NL-03-0753

VOGTLE ELECTRIC GENERATING PLANT  
REQUEST TO REVISE TECHNICAL SPECIFICATIONS  
REACTOR TRIP SYSTEM INSTRUMENTATION OVER TEMPERATURE DELTA  
TEMPERATURE (OTΔT) AND OVER POWER DELTA TEMPERATURE (OPΔT)  
REACTOR TRIP FUNCTIONS  
REQUEST FOR ADDITIONAL INFORMATION  
(REFERENCE: TAC NOS. MB 5046 and 5047)

**RESPONSES TO REQUEST FOR ADDITIONAL INFORMATION**

Figure 1

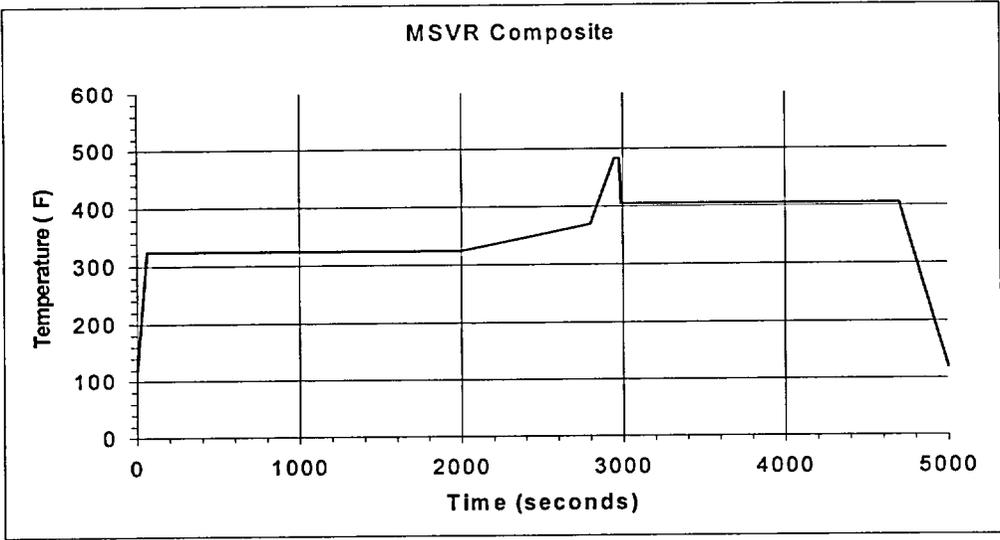
Provide curves of pressure and temperature as a function of time for the HELB outside containment.

Eighty five cases were run to construct a composite temperature profile. The composite profile is shown in Figure 1 below.
